## TECHNICAL BULLETIN

**407-17-125**

**MODEL AFFECTED:** 407

**SUBJECT:** AFT FUSELAGE 2-PIECE UPPER LEFT  
LONGERON ASSEMBLY 407-030-067-105,  
INSTALLATION OF.

**Figure 6 - Installation of New Aft Upper Left Longeron (Sheet 7 of 10)**

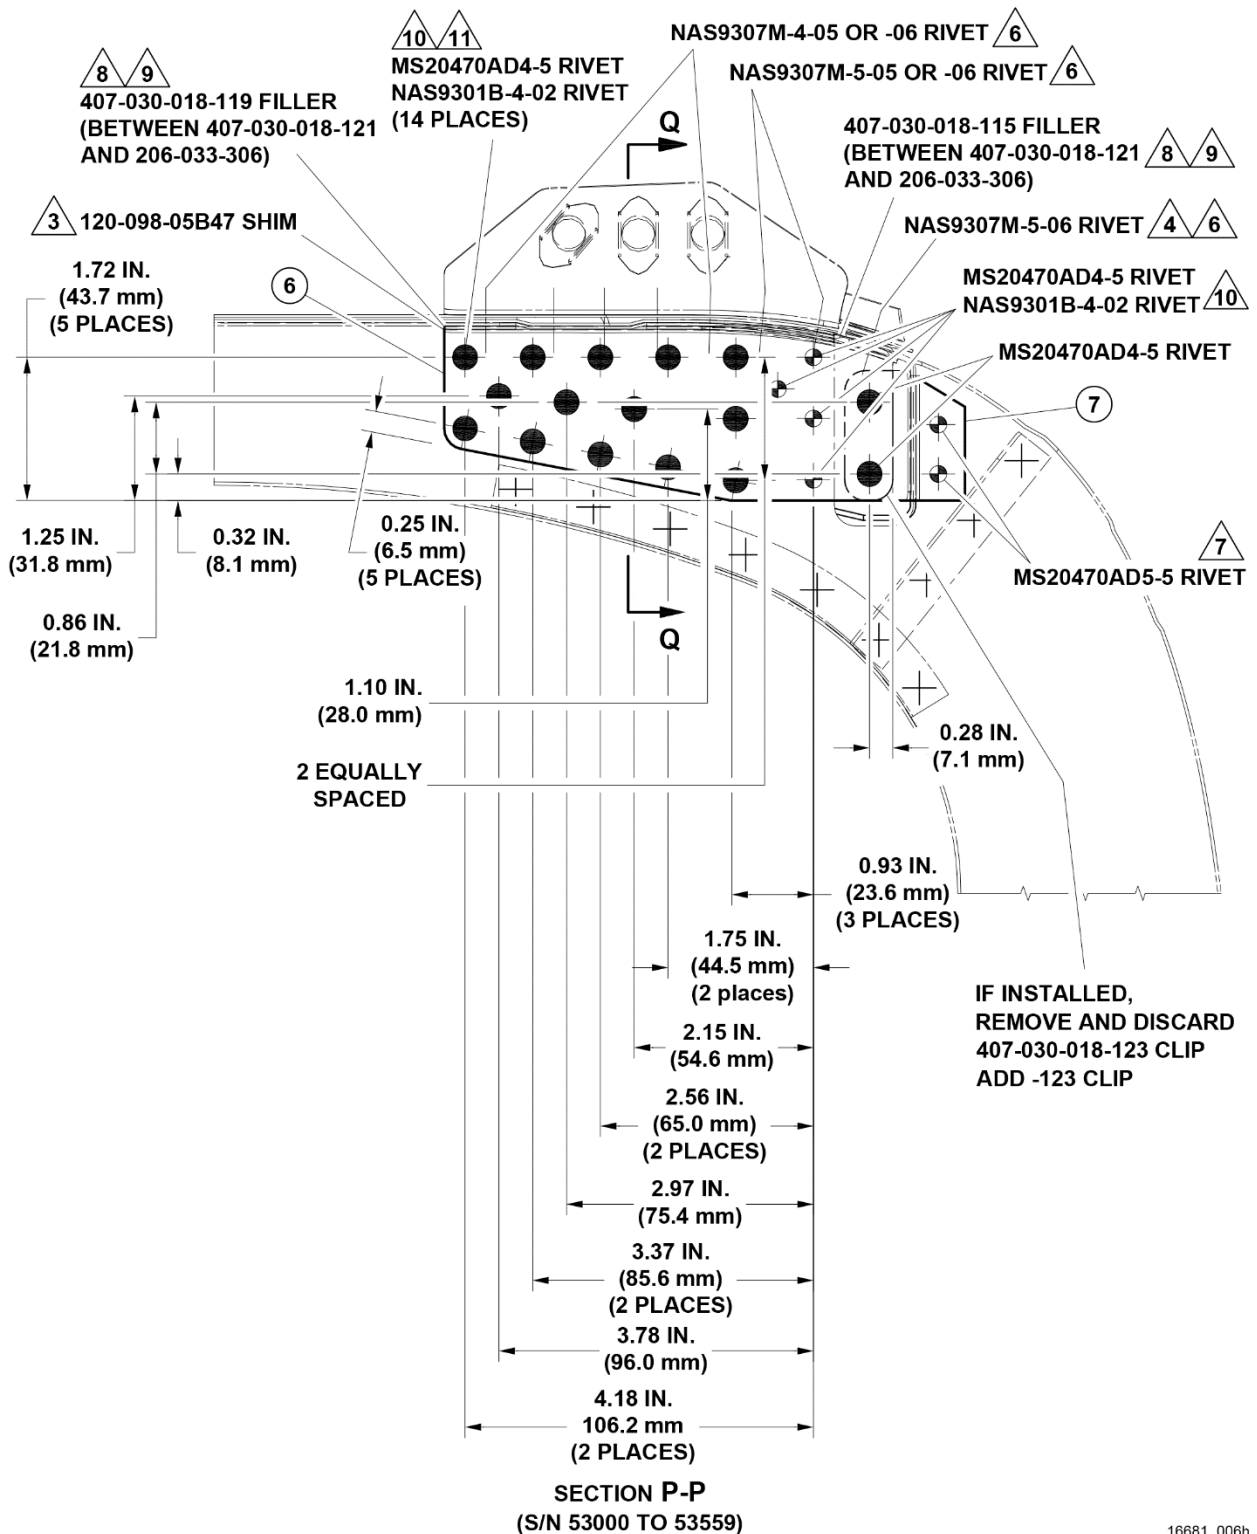
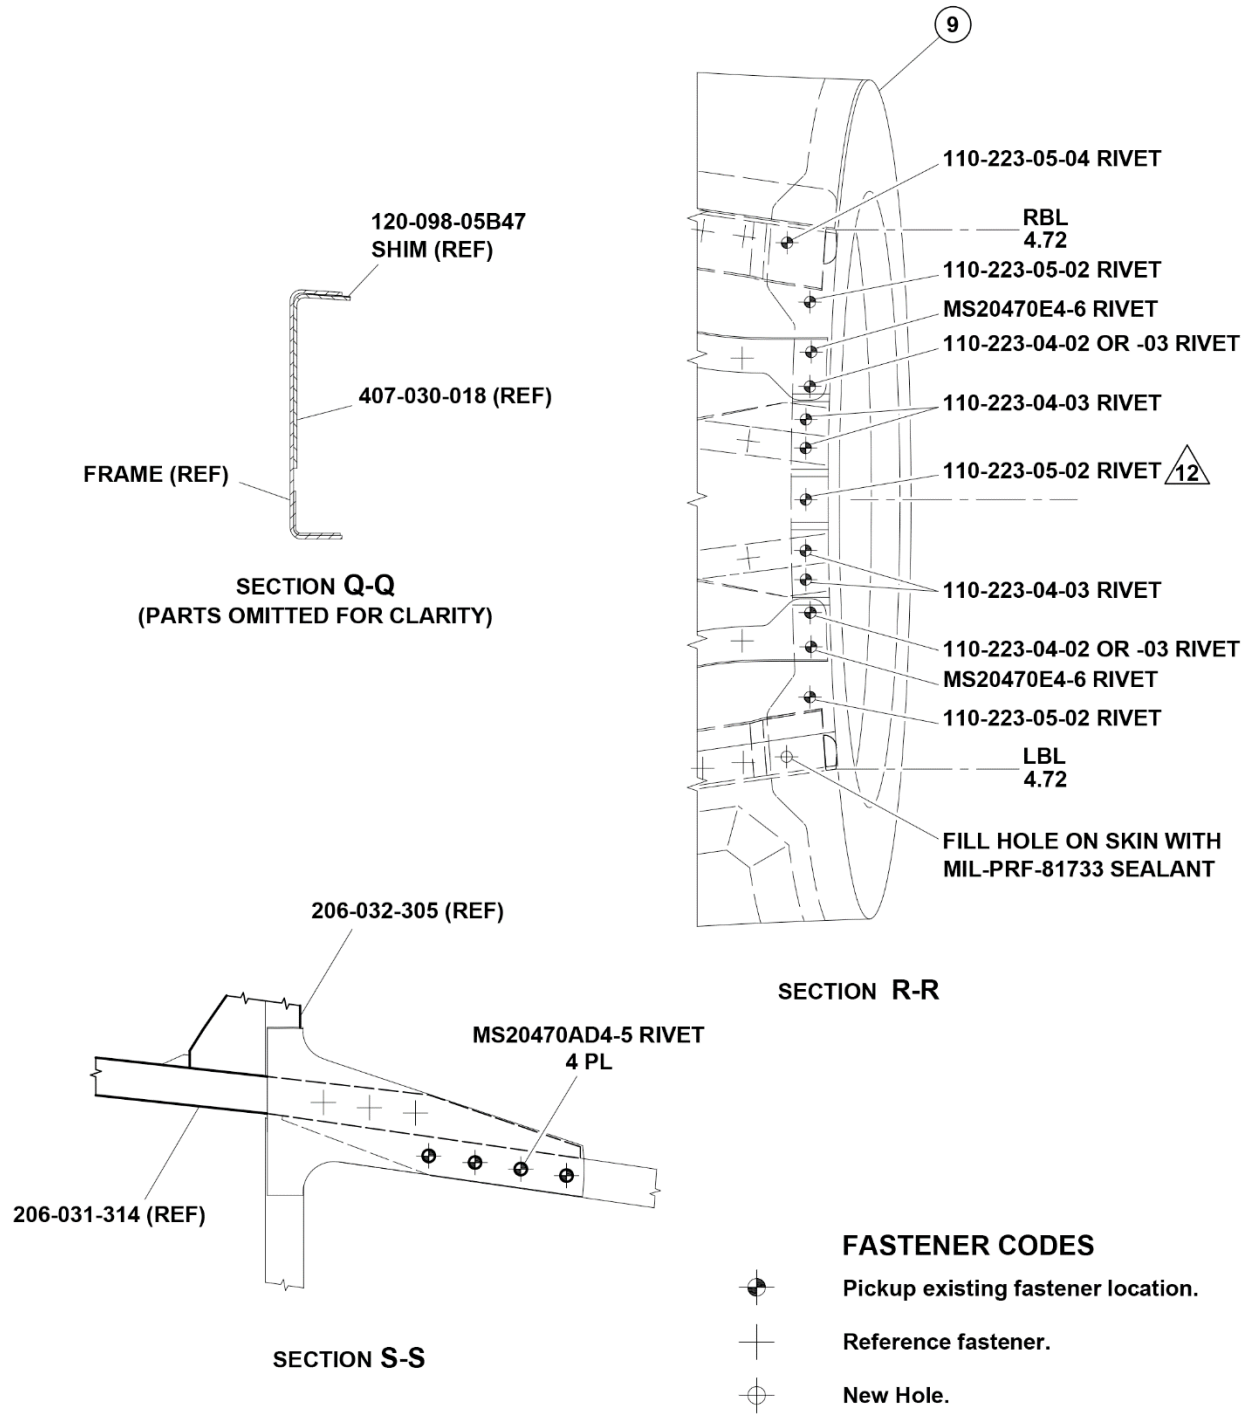
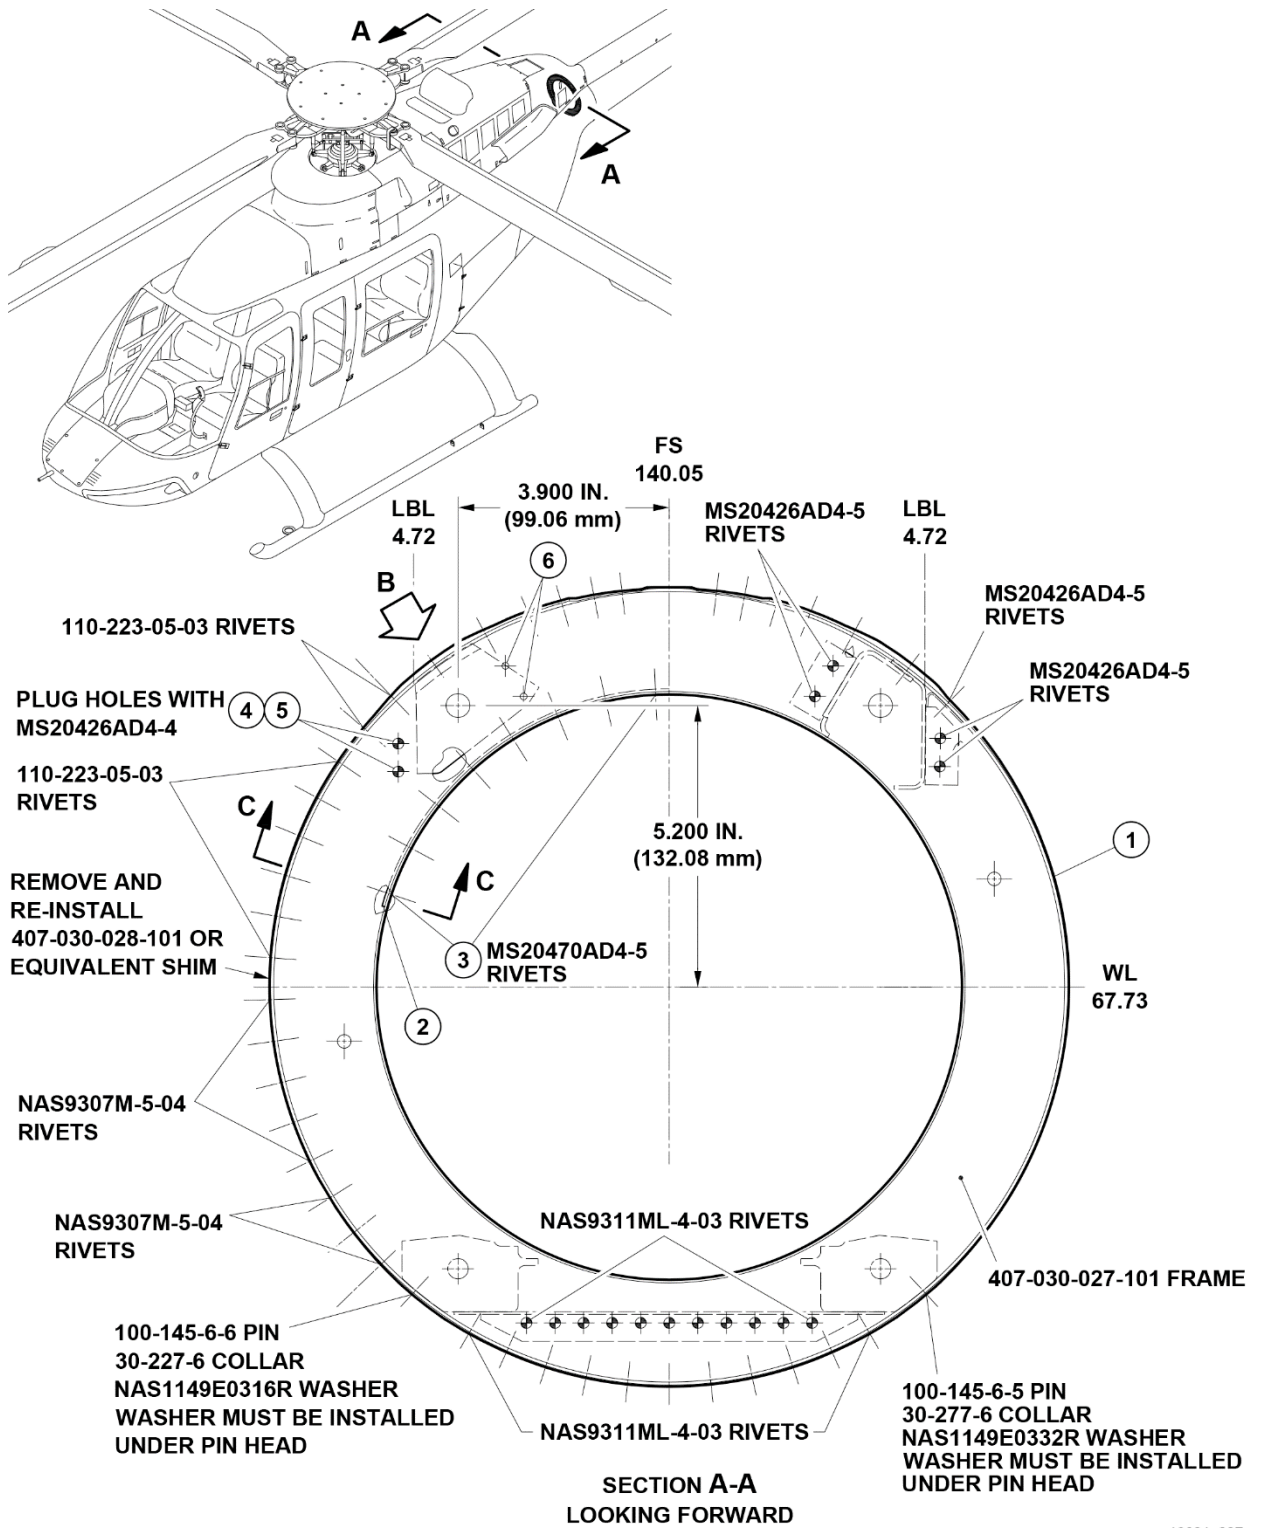
16. Countersink the two holes (2, Figure 6) and plug with rivets (3).
17. Position the new aft upper left longeron assembly (4, Figure 6) in place in the aft fuselage. If required, it is acceptable to slightly trim the sections shown on Section C-C, as per Note 1, to obtain an acceptable clearance between the new aft upper longeron and the airframe.

25. Transfer all fastener holes to aft upper left longeron assembly (1) while installing Clecocs after each drilling operation.
26. Position the new clips (1, 5, 6, 7, and 8, Figure 6), and transfer the existing holes from the aft fuselage and drill the new holes.
27. Identify which aft fuselage bulkhead (13, Figure 2) will be installed:

- 1 It is permissible to trim indicated edge of 206-032-307 frame while maintaining minimum 2D edge distance with existing fastener hole location in order to increase clearance with longeron bottom flange. Make sure that fillet and corner radii are 0.13 inch minimum after trimming.

- 2 If new fastener heads are found to fall into bend radius of clip, it is acceptable to repair IAW ALL-SRM 3-4-4 using only 2 fasteners common to clip and frame for radius block installation. If fastener hole is found to fall into bend radius of clip, contact Bell Product Support Engineering.

- 3 For gap of 0.008 inch or less, it is acceptable to shim using general purpose adhesive (C-317) and discard new shim. Otherwise, install shim between clip and frame with general purpose adhesive (C-317).

**Figure 7- Installation of a Machined Aft Fuselage Bulkhead 407-030-027-101  
(Sheet 2 of 2)**

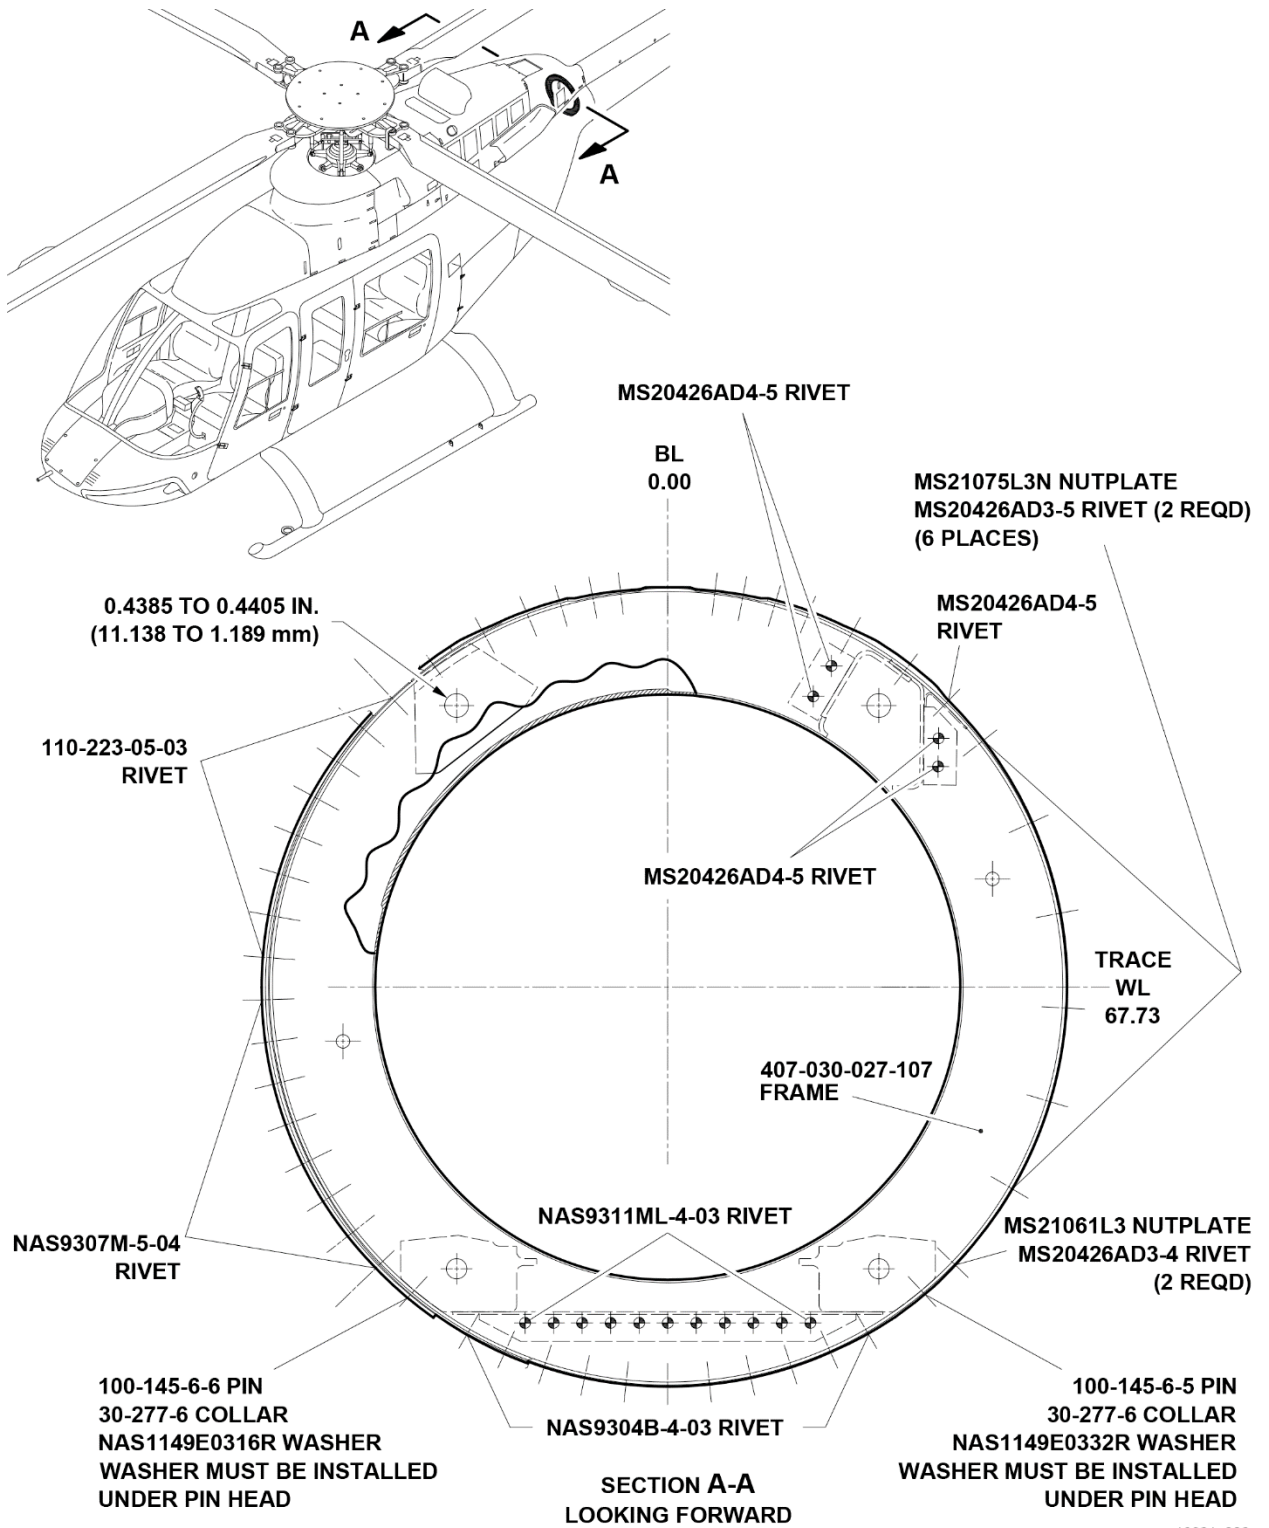
- a. It is not acceptable to use an older sheet metal aft fuselage bulkhead 206-032-308-103 and 206-032-308-121 during this process.
- b. If it was previously installed, it is acceptable to use the same machined aft fuselage bulkhead 407-030-027-101, but it must be modified as follows prior to installation:

- (1) Position the doubler (2, Figure 7) on the inner flange of the aft fuselage bulkhead (1) as shown and drill both parts simultaneously in preparation of the eight rivets to be installed.

- (2) Remove the doubler (2) from the inner flange of the aft fuselage bulkhead (1), deburr the holes, and clean with Isopropyl Alcohol (C-385).
  - (3) Bond the doubler (2) to the aft fuselage bulkhead (1) with adhesive (C-317) and secure with rivets (3).

- (4) Plug the two holes (4) using rivets (5).
  - (5) Leave open the two holes (6).
  - (6) Countersink hole (7) on both sides and plug with a double-flush rivet (8) (Figure 7).

**Figure 9 - Installation of External Strap Doublers (Sheet 1 of 2)**

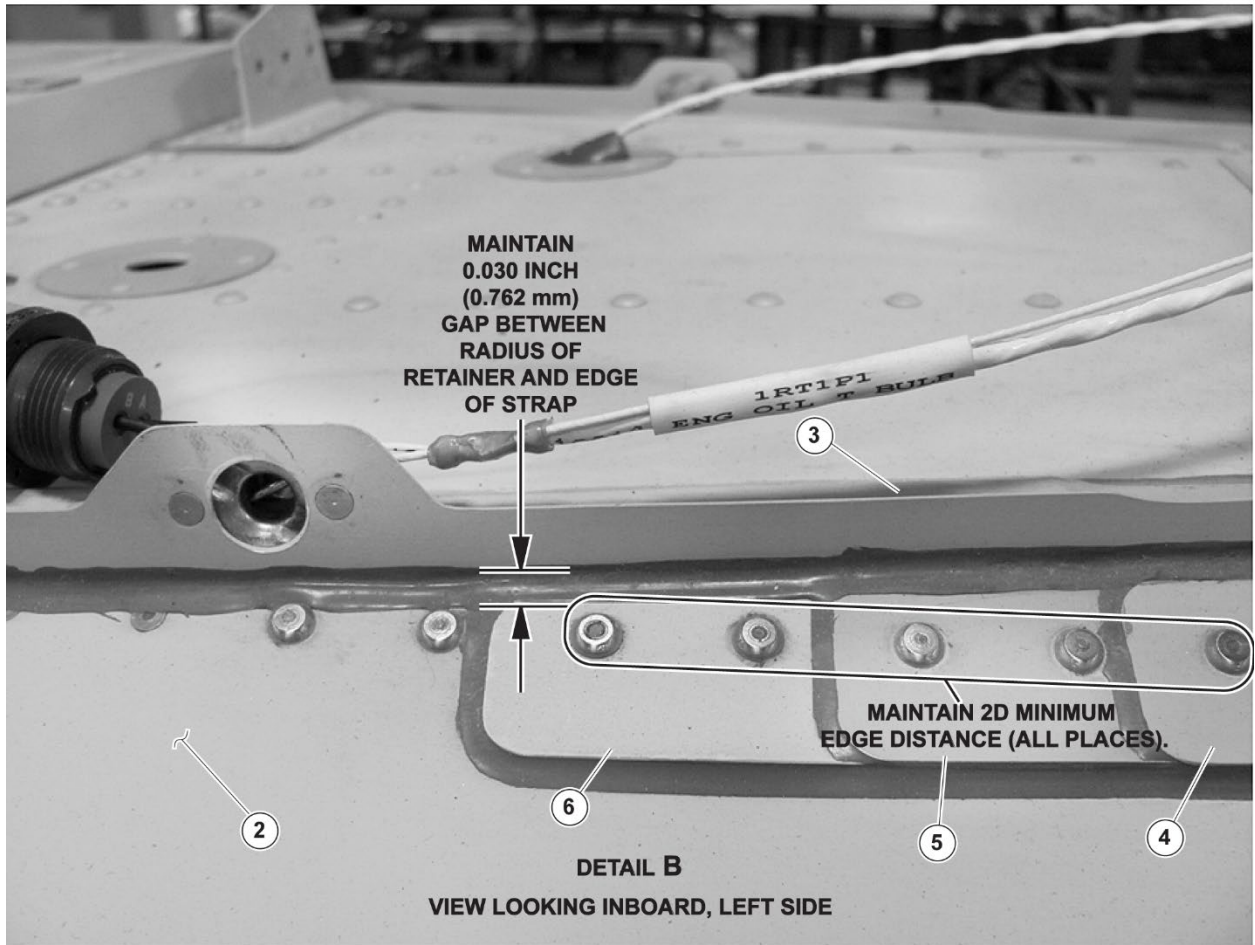
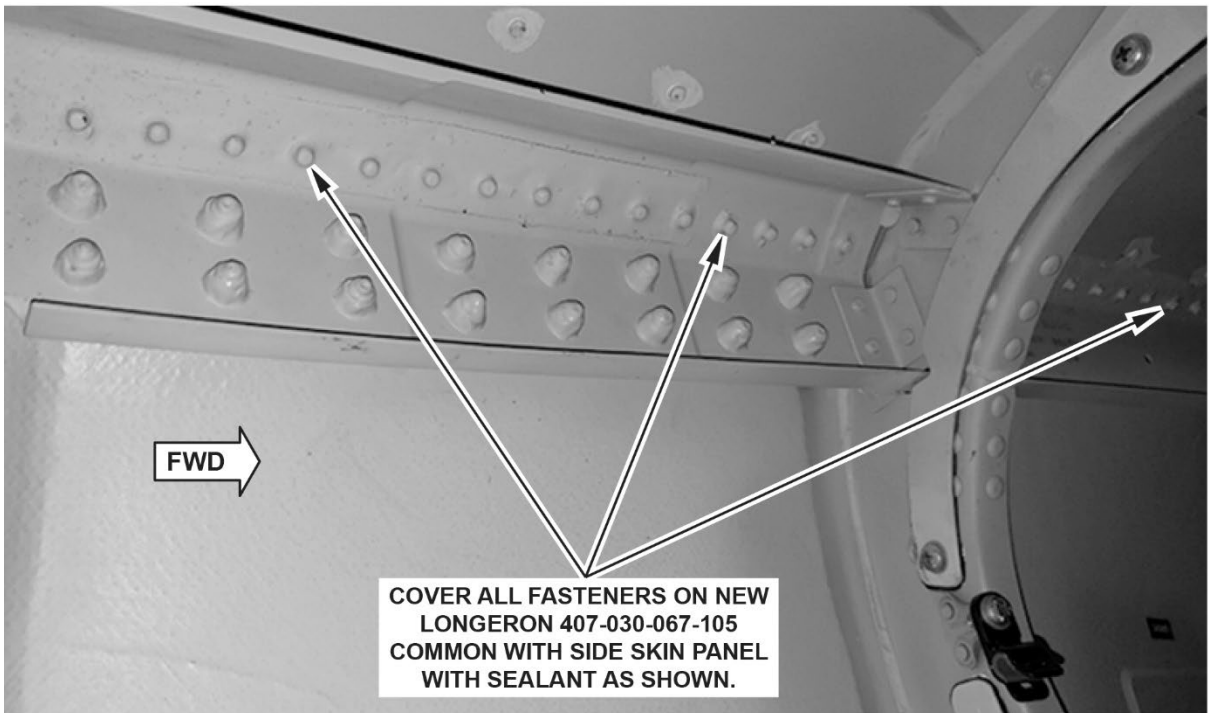
53. If not previously accomplished, install the three external strap doublers (4, 5, and 6, Figure 9) using the instructions found in PART III of ASB 407-11-95 and Figure 9 of this bulletin.
54. Coat all tips of new rivets visible from the inside of the fuselage with sealant (C-251) as shown (Figure 10).
55. Refinish internal and external surfaces with primer (C-204) and paint as required (BHT-ALL-SPM, Chapter 4).
56. Remove all protective covers previously installed on equipment located on canted web.
